The Seawall at Hawthorne Point

This report will review what is known about the seawall at Hawthorne Point. By exploring the history of the seawall, this report expresses the author's opinion that the currently damaged seawall requires reconstruction from the bedrock ledge. This report also critically examines the Notice of Intent (NOI #028-2597) and the Seawall Rehabilitation Study, rebutting key assumptions of option 1 and option 2 in the Seawall Rehabilitation Study.

view of section C showing the failed corner just below the two urns

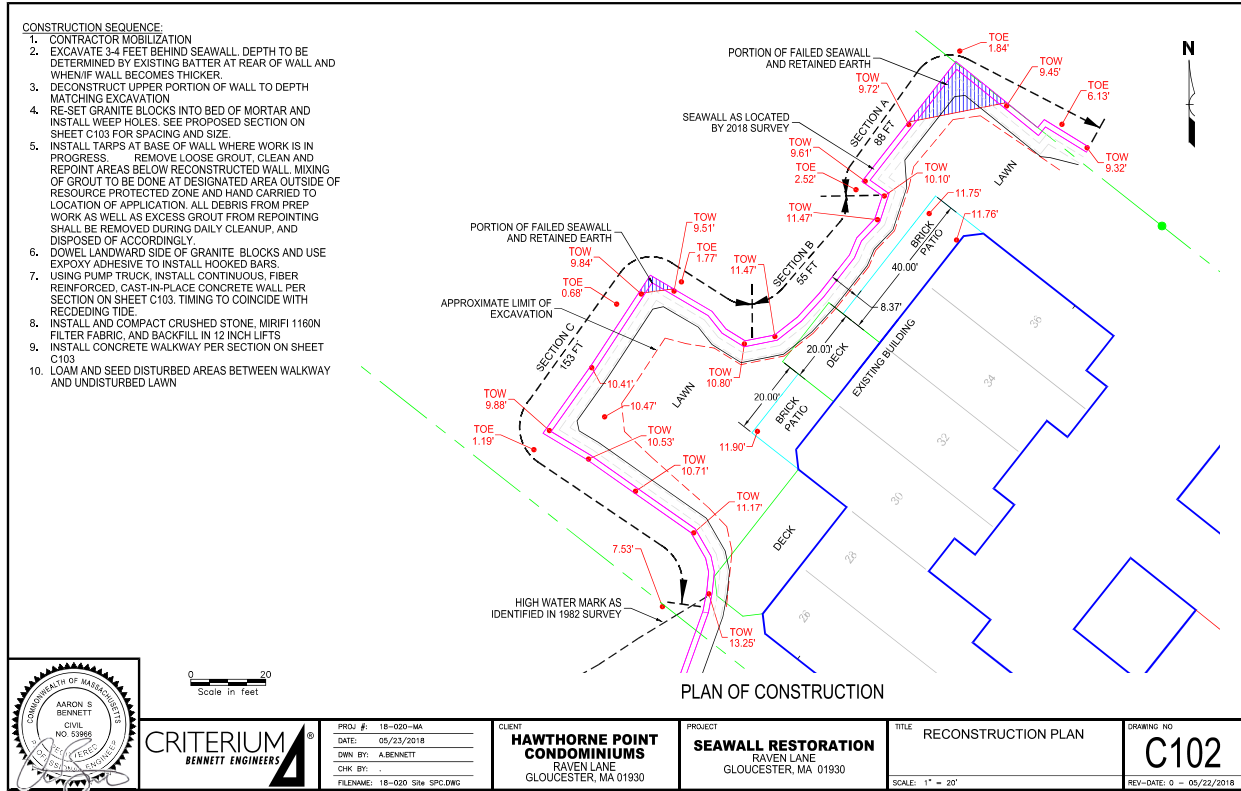
One area of concern is the portion of section A adjacent to the failed corner marked with a red arrow. The next photo shows a closer view of this part of section A starting from the failed corner.

The red arrow indicates an uncollapsed portion of section A which appears to be buckling. The stones indicated with green arrows adjacent to the buckled portion of the wall fell in a pattern consistent with a buckling failure of the corner of the wall.

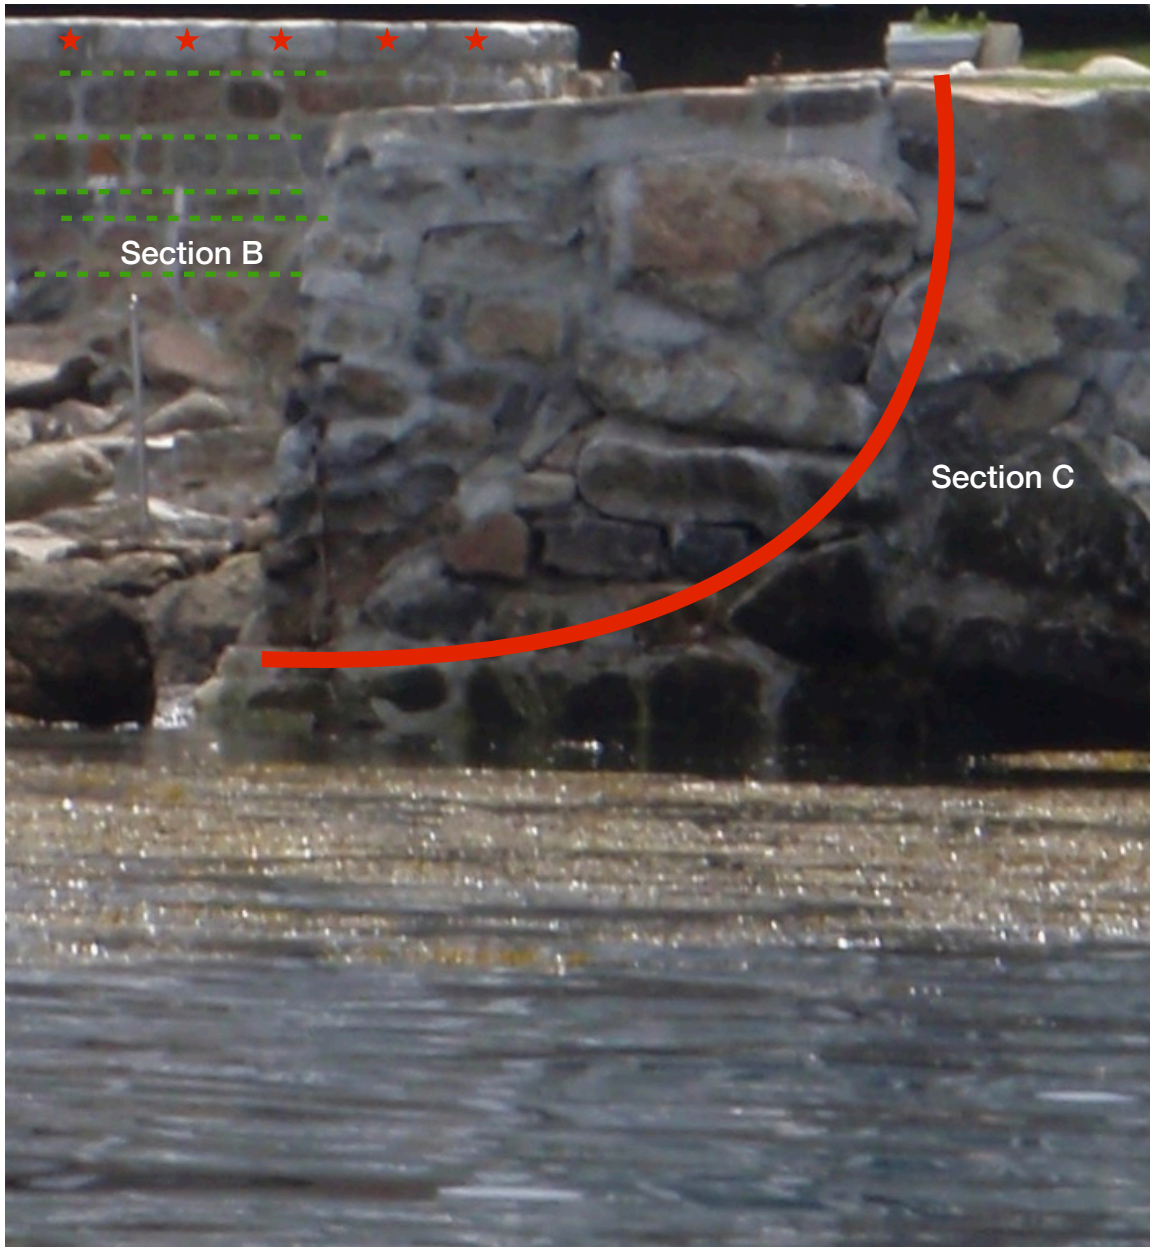
The leftmost inset on page 9 is expanded here to show a detailed portion of section B.

The top of the wall uses small dressed stones (marked with a red star) to cap a structure comprised of irregular stones mortared together. The masonry in this part of section B is somewhat irregular. The green dotted line indicates one possible course, but much of the masonry in the right side of the image consists of undressed stones mortared together irregularly. This is typical of rubble masonry.

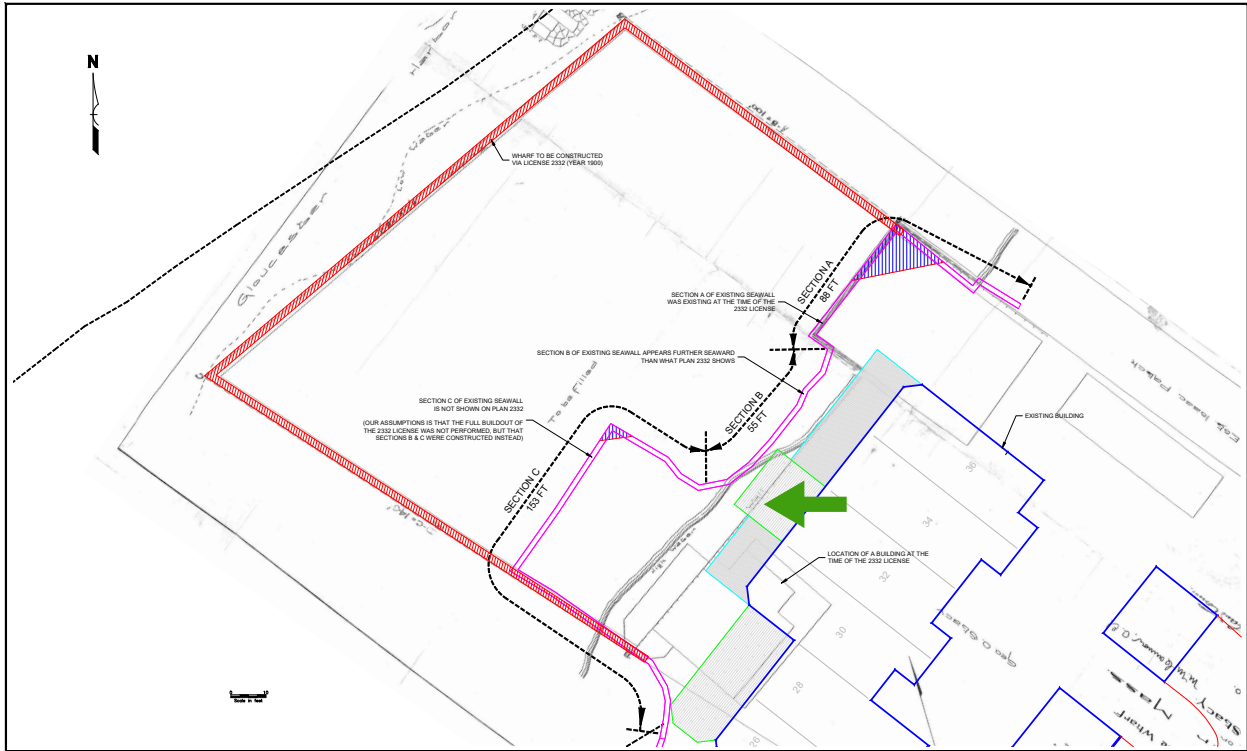
Section A lacks the capstones from more recent photographs (and the current conditions). Section A may also have an additional course of dressed stone; there is some difficulty in reconciling the dressed stones in the images.

Section B was more of a revetment than a wall in 1982. The slope of the revetment ends near the edge of the brick patios. Note that when the 1900 plan drawing is superimposed on the current engineering drawings, the edges of the brick patios are consistent with the 1900 line marked "Wall". (see green arrow on the next page).

Section C is also more of a revetment or a previously collapsed wall than in current conditions.

This photograph establishes that significant changes and rework have been applied to the seawall since construction of the condominiums.

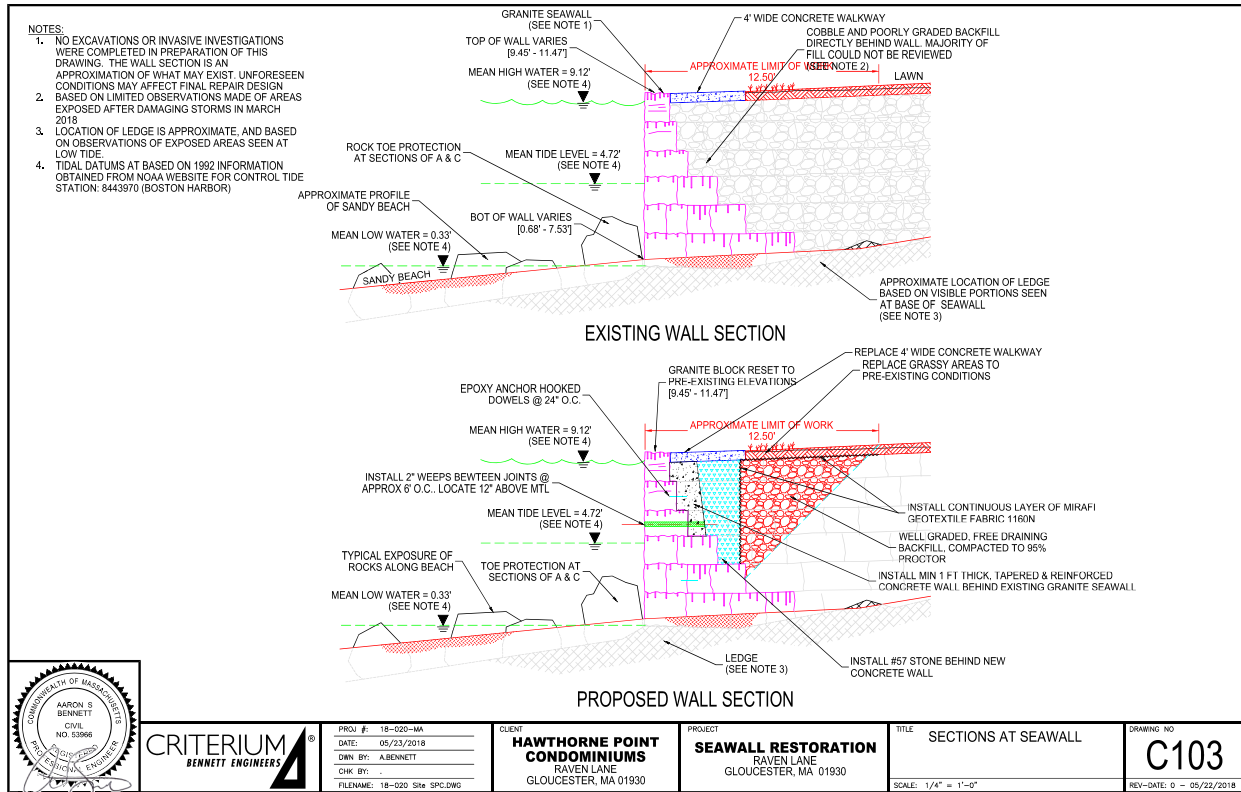
Drawing number C103 in the NOI illustrates these parameters. Note number 1 disclaims the accuracy of existing wall cross section:

“No excavations or invasive investigations were completed in preparation of this drawing. The wall section is an approximation of what may exist. Unforeseen conditions may affect final repair design.”

The second item of note are the levels for mean tide level just below the mid-point of the seawall and the mean high water, only inches below to top edge of the seawall. The tide levels are relevant to the discussion in the next section.

The response given was “No”. This is internally inconsistent with the drawing C103 shown in the previous section. The drawing shows the majority of the damaged structure is below mean high water.

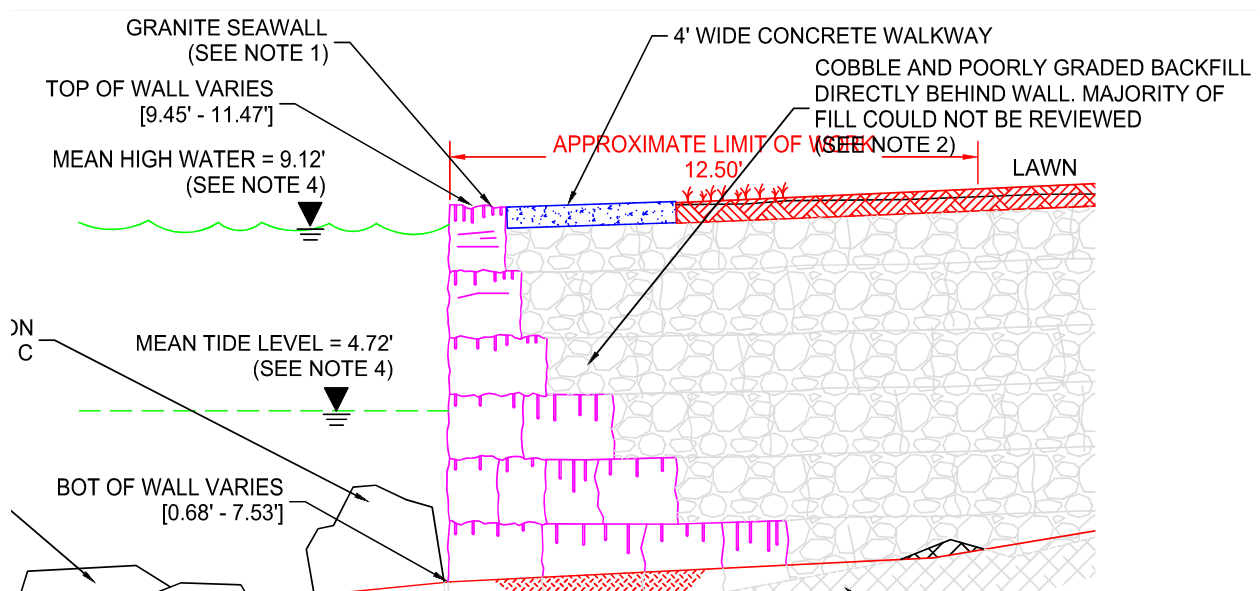
The key contingency in the NOI is that “excavation is only anticipated to a depth where the thickness of the stacked granite block becomes greater than 5-6 feet from the face of the wall”. Thus option 1, option 2 and the work proposed by the NOI are all predicated on the existence of a seawall cross section as shown in drawing C103, the key inset shown here. Notice the increasing thickness of the wall with depth. This is not consistent with the current conditions detailed in the first section of this report.

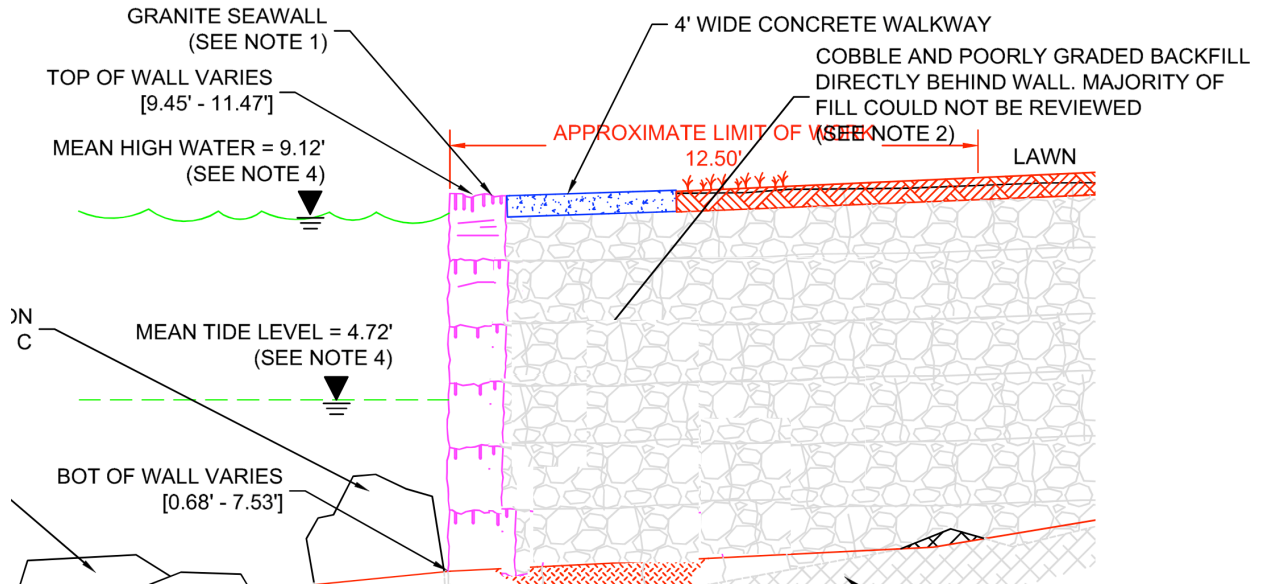
The exposed portions of the seawall, the wreckage from the failed sections and the historical photographs all suggest that the seawall cross section is more likely to look like the following figure, where a facade of dressed stone retains a rubble layer.

Should this figure more closely represent the existing structure, then “excavation ... to a depth where the thickness of the stacked granite block becomes greater than 5-6 feet from the face of the wall” will naturally lead to option 3, where the entire wall is deconstructed. The main difference relative to option 3 might be that after the structural concrete layer is installed, a facade of dressed stone is used to conceal the bulk of the concrete.
